PCN#20150123003 Qualification of Hitachi as Additional Assembly/Test location for Select Devices in the DCU package Change Notification / Sample Request

Date: 1/26/2015

PCN N	PCN Number: 20150123003 PCN Date: 1/26/2015								1/26/2015		
Title:	Qualification of HIT as Additional Assembly/Test location for Select Devices in the DCU package										
Customer Contact: PCN Manager					D	Dept: Quality Services					
Proposed 1 st Ship Date: 04/26/201				1/26/2015		Ferimated Sample Availability:					e provided on request
Chang	Change Type:										
\triangle	Assembly Sit	e		Assembl	уΡ	rocess		\boxtimes	Assembly Materials		
	Design			Electrica	l Sp	pecificat	ion		Mechanical Specification		
	est Site			Packing/	Packing/Shipping/Labeling				Test Process		
V	Wafer Bump	Site		Wafer Bu	Wafer Bump Material				Wafer Bump Process		
V	Wafer Fab Si	te		Wafer Fa	Wafer Fab Materials Wafer Fab Proces					roces	SS
	☐ Part number change										
	PCN Details										
Descri	Description of Change:										
	·

Example:

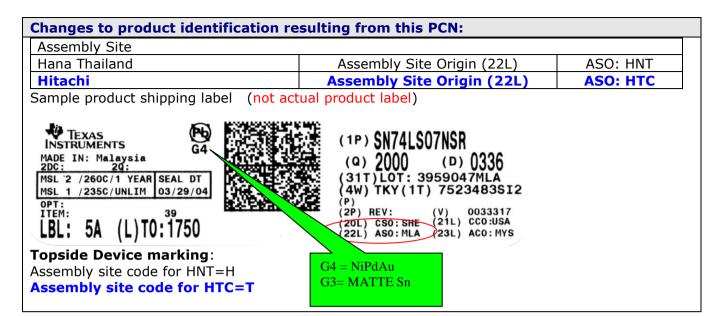
Upon expiry of this PCN TI will combine lead free solutions in a single <u>standard part number</u>, for example; <u>SN74AVCH2T45DCUR</u> – can ship with both Matte Sn and NiPdAu/Ag.

- Customer order for 7500units of SN74AVCH2T45DCUR with 2500 units SPQ (Standard Pack Quantity per Reel).
- TI can satisfy the above order in one of the following ways.
 - I. 3 Reels of NiPdAu finish.
 - II. 3 Reels of Matte Sn finish
 - III. 2 Reels of Matte Sn and 1 reel of NiPdAu finish.
 - IV. 2 Reels of NiPdAu and 1 reel of Matte Sn finish.
